Access Compliance Report

Public Rights-of-Way

(Curb Ramps)

Intersection ID: 42838	Main Street: SARDIS_OAKS_RD	Cross Street: SARDIS_RD_NORTH	Location: SW
ADA ID: 250F0D7FEB15	Ramp Type: BlendTrans2	Initial Pass/Fail: Fail	Overall Compliance: No
		Severity Score: 21.25

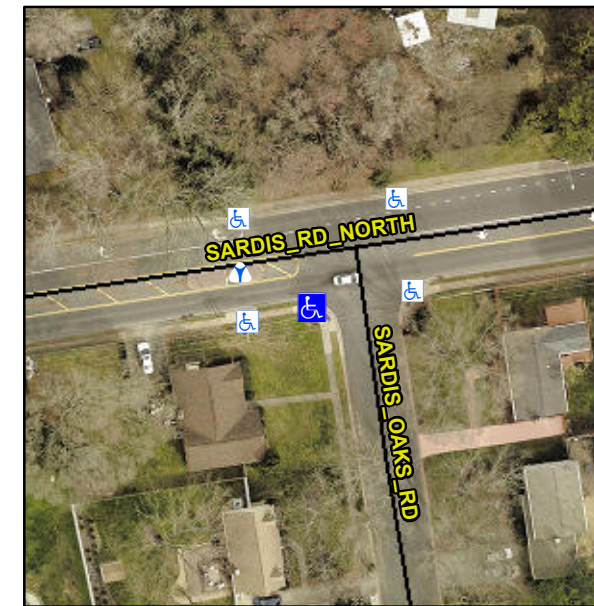
Not Found, R304.5.1, R304.5.3

Compliance	Description	Data	Compliance	Description	Data
N/A	Ramp Length (in)	75.0	Yes	BlendTrans Slope (%)	3.3
No	Ramp Width (in)	41.0	No	BlendTrans XSlope (%)	5.4
N/A	Flare Type LT	N/A	N/A	Flare Type RT	N/A
N/A	Flare Slope LT (%)	N/A	N/A	Flare Slope RT (%)	N/A
N/A	Flare Traversable LT?	N/A	N/A	Flare Traversable RT?	N/A
N/A	Landing Length (in)	N/A	N/A	DWS Provided?	N/A
N/A	Landing Width (in)	N/A	N/A	DWS Contrast?	N/A
N/A	Landing Slope (%)	N/A	N/A	DWS Length (in)	N/A
N/A	Landing X Slope (%)	N/A	N/A	DWS Full Width?	N/A
N/A	Landing Curb? (Y/N)	N/A	N/A	DWS Offset (in)	N/A
N/A	Shared Landing?	N/A			
N/A	Gutter Ponding?	N/A	N/A	Gutter Slope (%)	N/A
N/A	Gutter Lip Ht (in)	N/A	N/A	Gutter X Slope (%)	N/A
N/A	Painted X Walk1?	No	N/A	Painted X Walk2?	No
	X Walk 1 Direction	To E		X Walk 2 Direction	To N
	X Walk 1 Width (in)	N/A		X Walk 2 Width (in)	N/A
	X Walk 1 Slope (%)	2.0		X Walk 2 Slope (%)	2.6
	X Walk 1 X Slope (%)	3.1		X Walk 2 X Slope (%)	2.5

N/A	Ramp inside XWalk1?	N/A	N/A	Ramp inside XWalk2?	N/A
	Road Slope (%)	3.9		Clear Space?	N/A
	Road X Slope (%)	2.0	N/A	Clear Space to XWalk (in)	N/A
N/A	Any Obstructions?	N/A	N/A	Storm Grate/Utility Hazard?	N/A
	Obstruction Type			Storm Grate/Utility Type	
		N/A			N/A
			Yes	Surface Condition? (G/P)	Good
			No	Curb Slope (%)	7.3

Remove & Replace Curb Ramp With Two New Directional Ramps or Equivalent.
